RE: Response to Information Request

Development Permit for Material Change of Use for Multiple Dwelling and
Building Work within the Flood Overlay

17, 19 & 21 Maud Street, Newstead QLD 4006 – A007068254

Figure 3. Assessment of Impact on Visual Prominence of Montpellier Hill

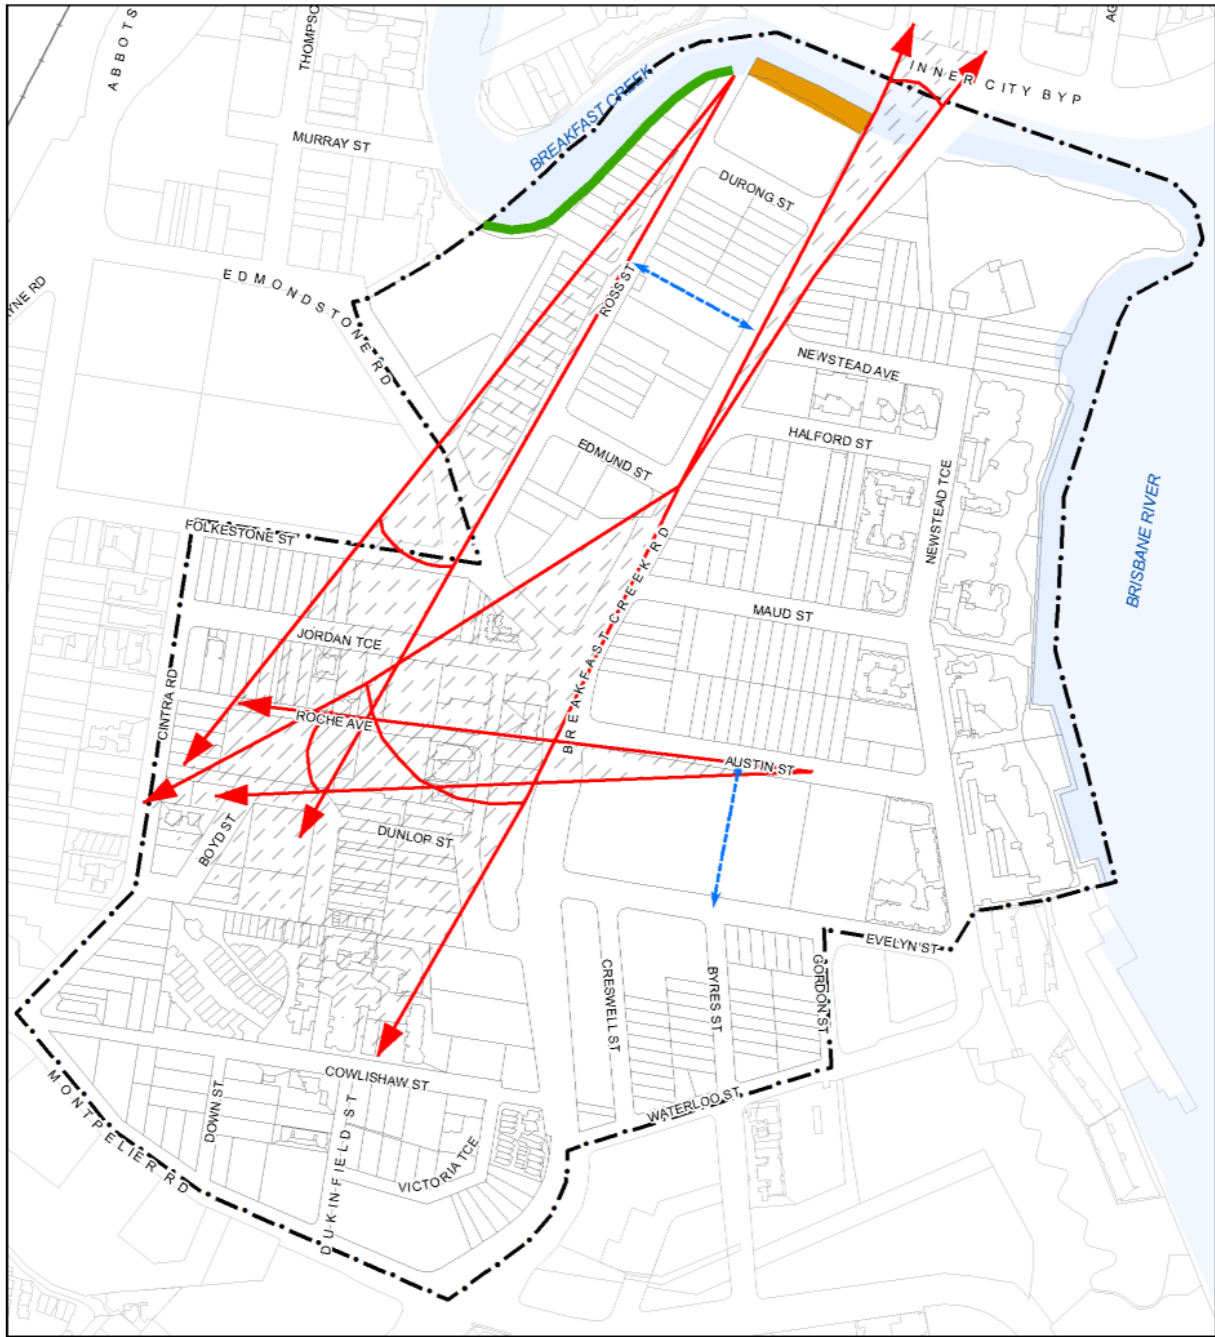
The proposed development in its current form is considered to result in undue amenity impacts and will reduce the visual prominence of Montpelier Hill (PO1 of the Newstead North Neighbourhood Plan).

Information submitted with the development application demonstrates the proposal does not reduce the visual prominence of Montpelier Hill. As demonstrated in **Figure 2** below, the key public realm views to Montpelier Hill are from Breakfast Creek Road, Ross Street and Austin Street. The location of the proposed development does not impact on these priority view corridors.

Notwithstanding this, and as demonstrated in **Figure 3**, views to Montpelier Hill have been considered as follows:

- The long range view from Kingsford Smith Drive demonstrates that approved or constructed development in Newstead creates a built form backdrop adjacent to or behind the subject site and closer to Montpelier Hill. The proposal when placed relative to this backdrop does not introduce any reduction to the visual prominence of Montpelier Hill

- The short range view taken from eye level in Maud Street demonstrates that the proposed development does not impact the visual prominence of Montpelier Hill and further, that impact is unchanged irrespective of building height.

Figure 4. Roof Terrace Diagram

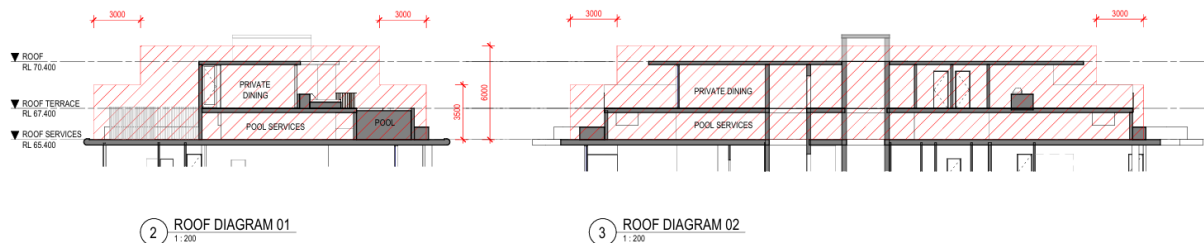
- a. Reduce the height of the tower to be more consistent with the intended height for the location.
- b. Review the assessment of the 'rooftop garden' definition and ensure that all heights above the rooftop level comply with those specified in the definition.

With respect to the proposed rooftop garden, the design incorporates a pool level platform and integrates arrival at this level. As per **Figure 4** below, measurements have been amended to apply from the top of roof (servicing sub-floor). The rooftop garden is designed to be located within the measurement parameters of a rooftop garden, with the minor exception of lift overrun which by necessity protrudes through the 6m overall height measure.

Figure 6. Comparison of Plan Revisions – Access to Substation

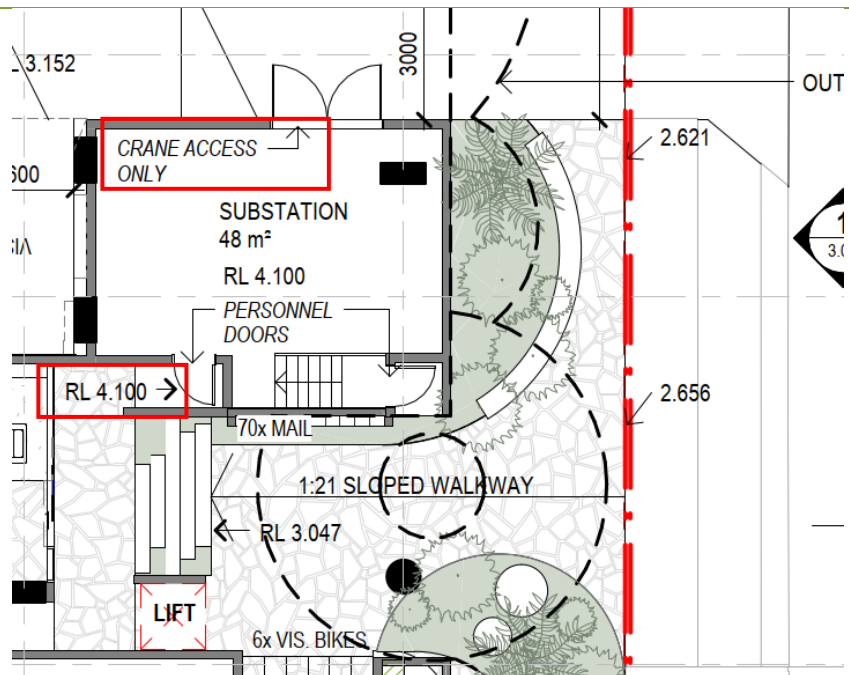
5. There appears to be a significant level difference between the substation levels and the ramp access levels on ground floor. This difference appears to be approximately 1.1m and result in a drop at the door to the substation. Further clarification is required to ensure the design is practical and safe.

- a. Amend the proposed plans as required to ensure the area functions safely. Carparking changes may need to occur in order to ensure sufficient access is provided.

The proposed substation shall generally be accessed day to day via a dedicated entry point next to the main pedestrian entry. Access via the carpark ramp is intended solely for crane access and will not form part of regular substation access arrangements. As illustrated in **Figure 6** below, the accompanying **Architectural Plans** have been amended to clearly identify the level of the dedicated substation entry and annotate access from the ramp as 'Crane Access Only.'

Figure 7. Comparison of Plan Revisions – Fire Door Access

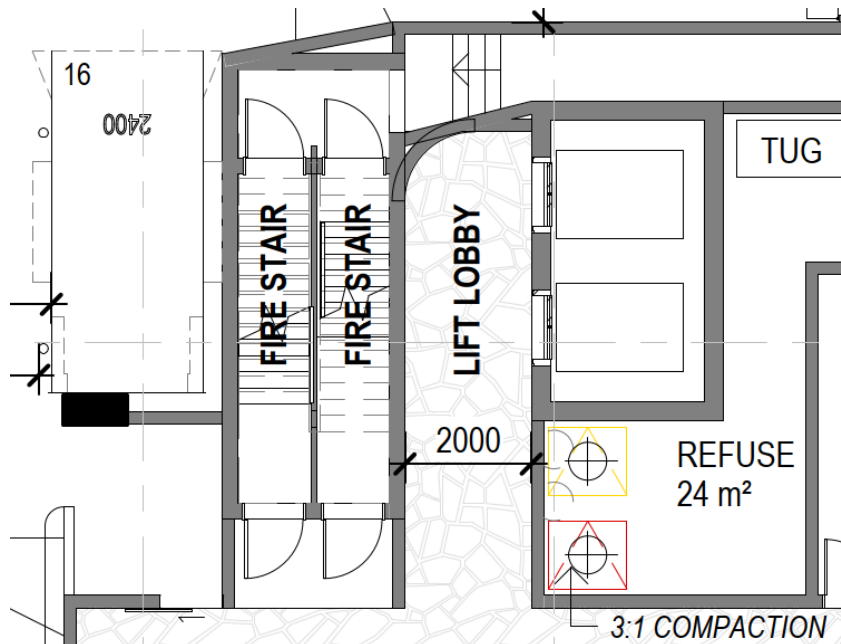
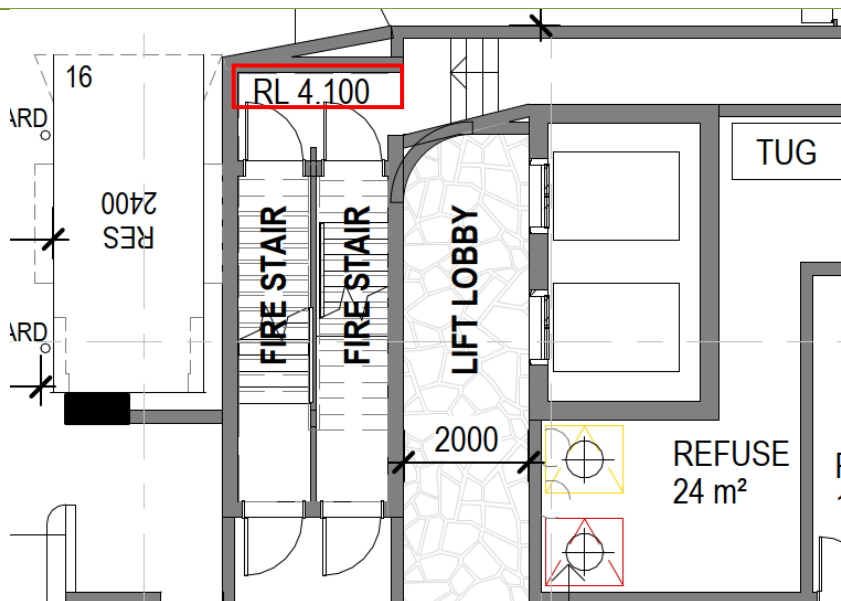
6. There appears to be a potential flooding concern with basement flooding via the fire door access located at approx. 3.47m AHD on the Ground level. Further information is required to ensure that the area is appropriately flood proof.

- a. Provide finished floor levels to lobby and the fire stairwell.
7. There is a concern with the parking safety of spaces G-16; B1-22; B2-22; B3-22 which, with aisles less than 6.20m wide have the potential to result in property damage, even at low speeds. Consider safety in design mitigation measures for these spaces.

The fire door access is located at RL 4.1m, exceeding the adopted highest flood level of RL 3.6m and ensuring safe access above the defined flood level. As illustrated in **Figure 7** below, submitted **Architectural Plans** have been amended to clearly depict the levels associated with the fire door access.

Figure 8. Access to Bicycle Storage Area

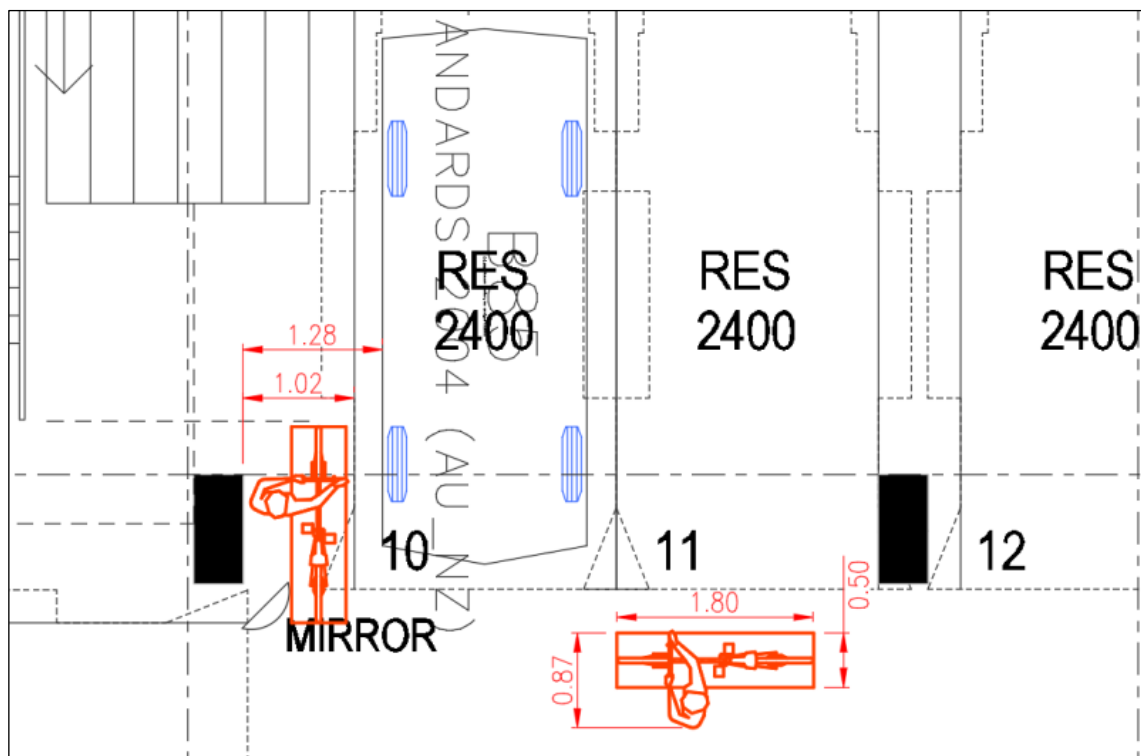
8. The access aisle to the resident bicycle parking area adjacent to car space 10 on the ground floor is non-compliant. The width should be approximately 1.5m to ensure a person is able to walk through next to their bicycle and the plans indicate a width of 1m. Review the current design and consider deleting car space 10 to accommodate safe bike / walking rider access in accordance with AS2890.3. The car space may be suitable to remove altogether or change to a small parking space.

As per **Figure**, residents will be able to comfortably gain access to the bicycle storage area whilst wheeling a 0.5m wide bicycle. Please refer to the accompanying **Traffic Engineering Response** for further detail.

Figure 9. Sightline Splay

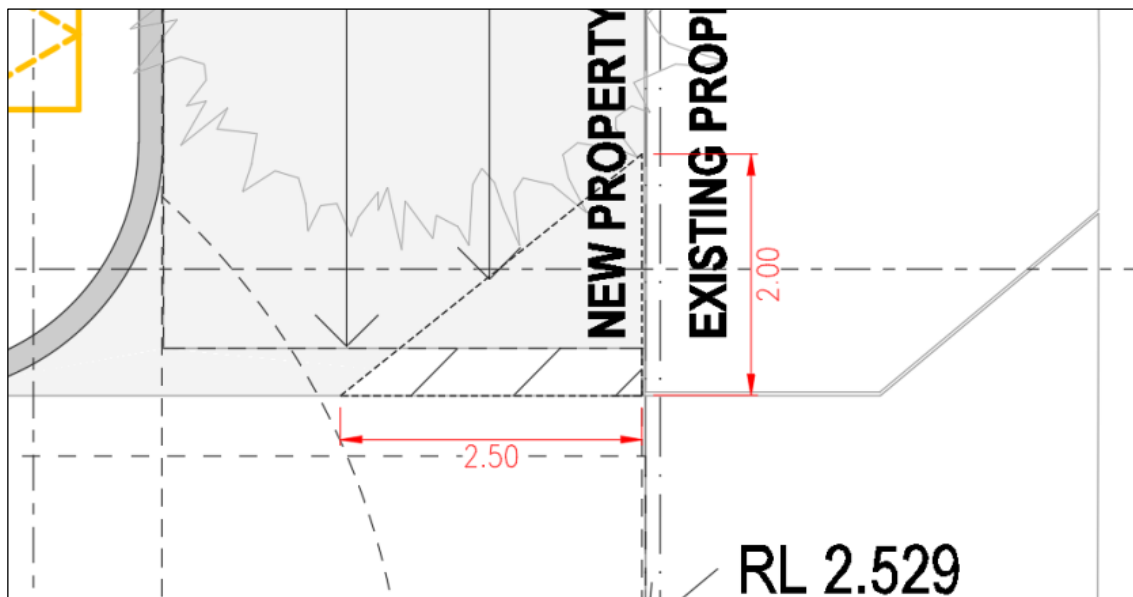
9. Provide amended plans with a pedestrian sightline splay, 2m x 2m, as per fig C of TAPS PSP, to the exit driveway.

As per **Figure**, the proposed development provides for a 2.5m x 2.0m sightline splay on the exit side of the vehicular crossover. Please refer to the accompanying **Traffic Engineering Response** and amended **Architectural Plans** for further detail.

Figure 10. Interface with Adjoining Development (Aire)

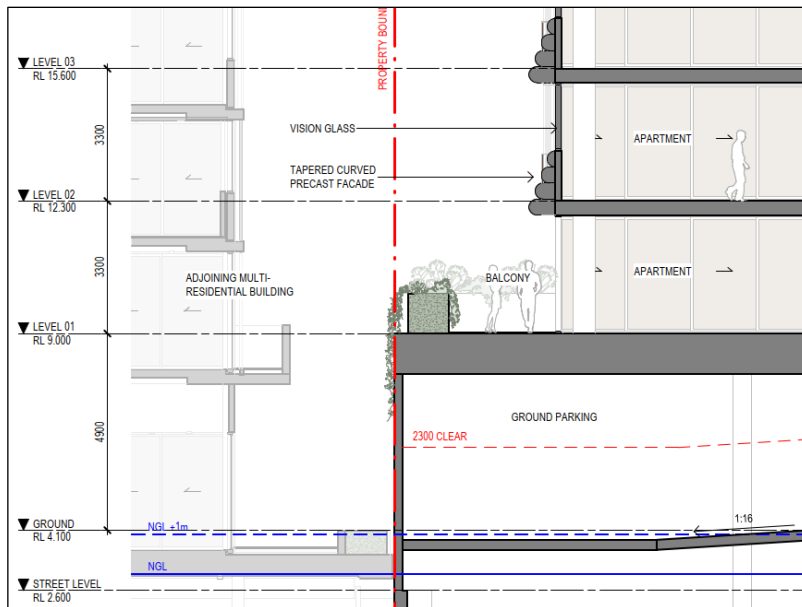
13. The proposed development includes habitable rooms with windows orientated to the side and rear boundaries which are less than the 24m distance described as an acceptable outcome for levels above 9 storeys and above in AO27.1 and AO27.2 of the Centre or Mixed-Use Code. It is not apparent that the design ensures privacy and amenity for adjacent sites has been protected nor is it apparent that future development has been considered for adjacent sites (PO27).

- a. Provide greater separation between existing and future development on adjacent sites.

The separation between the subject building and Aire remains between 7.48 and 8m to the glazing line. This outcome is commonly found between side boundaries across Brisbane, with some specific examples in Newstead provided towards the end of this response.

The approved floor plan for Aire is set out similarly to the subject development, whereby all balconies and primary living spaces are oriented to the street and rear of the building. The layout includes western facing windows towards the subject site, which have been approved with screening, maintaining privacy between the two buildings.

In addition, the variation in floor levels to be established between the two buildings, combined with the precast slab projections on the proposed development, obscure the cone of vision in many locations along the side elevation (Refer to **Figure 10**).
